UNITED STATES PATENT AND TRADEMARK OFFICE

APPLICATION NO.	FILING DATE	FIRST NAMED INVENTOR	ATTORNEY DOCKET NO.	CONFIRMATION NO.	
10/733,170	12/11/2003	Sung-Kyu Hong	8071-51 (OPP 021424 US) 5948		
22150	7590 05/20/2005	EXAMINER		INER	
F. CHAU & ASSOCIATES, LLC 130 WOODBURY ROAD			TRAN, LONG K		
WOODBURY, NY 11797			ART UNIT	PAPER NUMBER	
			2818		
			DATE MAILED: 05/20/2005	DATE MAILED: 05/20/2005

Application No.	Applicant(s)			
Office Action Summary	10/733,170	HONG ET AL.			
onice Action Summary	Examiner	Art Unit			
The MAU INC DATE of this communication ann	Long K. Tran	2818			
The MAILING DATE of this communication apperent of the Reply	ears on the cover sheet with the c	prrespondence address			
A SHORTENED STATUTORY PERIOD FOR REPLY THE MAILING DATE OF THIS COMMUNICATION. - Extensions of time may be available under the provisions of 37 CFR 1.13 after SIX (6) MONTHS from the mailing date of this communication. - If the period for reply specified above is less than thirty (30) days, a reply If NO period for reply is specified above, the maximum statutory period we Failure to reply within the set or extended period for reply will, by statute, Any reply received by the Office late

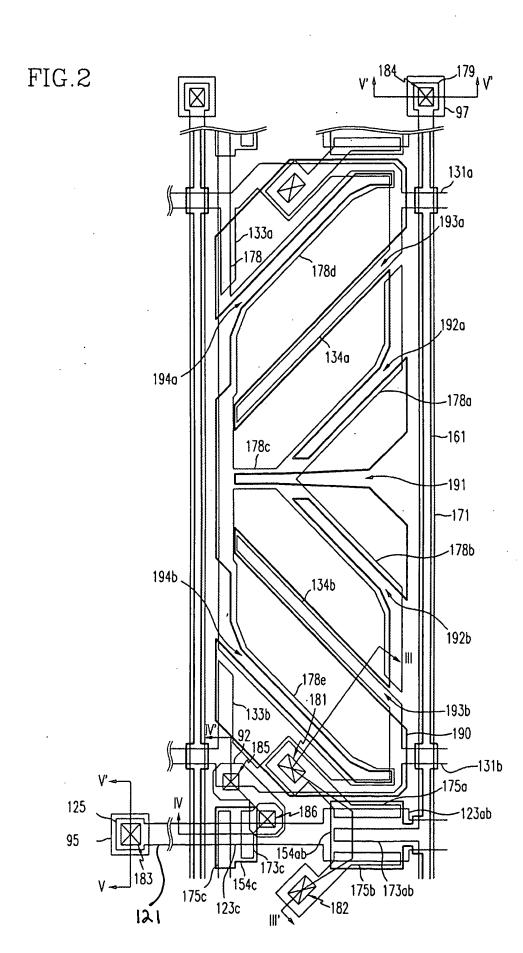
- 2. The following changes to the drawings have been approved by the examiner and agreed upon by applicant (on May 18, 2005): Figure 2 has been changed per attached drawing. In order to avoid abandonment of the application, applicant must make these above agreed upon drawing changes.
- The Patent and Trademark Office no longer makes drawing changes. See 1017O.G. 4. It is applicant's responsibility to ensure that the drawings are corrected.Corrections must be made in accordance with the instructions below.
